Access Compliance Report
Public Rights-of-Way
(Curb Ramps)

Main Street: ERVIN_LN | **Cross Street: WINTHROPE_ST** | **Location: SE**

ADA ID: RPAT211026130302 | **Ramp Type: Type 4 - Parallel** | **Initial Pass/Fail: Fail** | **Overall Compliance: No** | **Severity Score: 2**

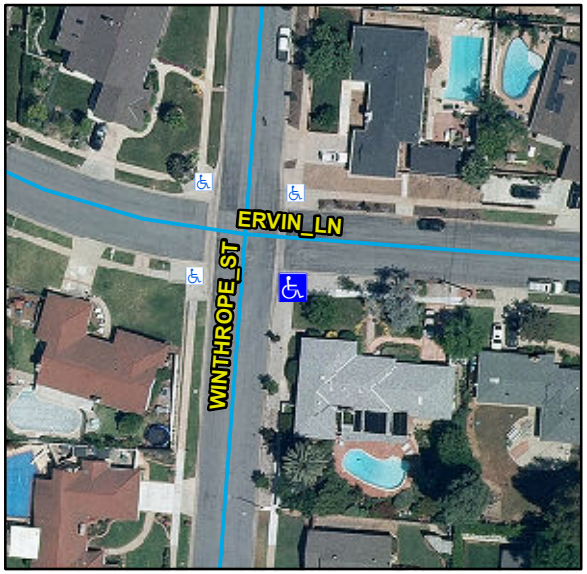
R204.3, R304.5.3, STD 1115

Remove & Replace Curb Ramp With Two New Directional Ramps or Equivalent.
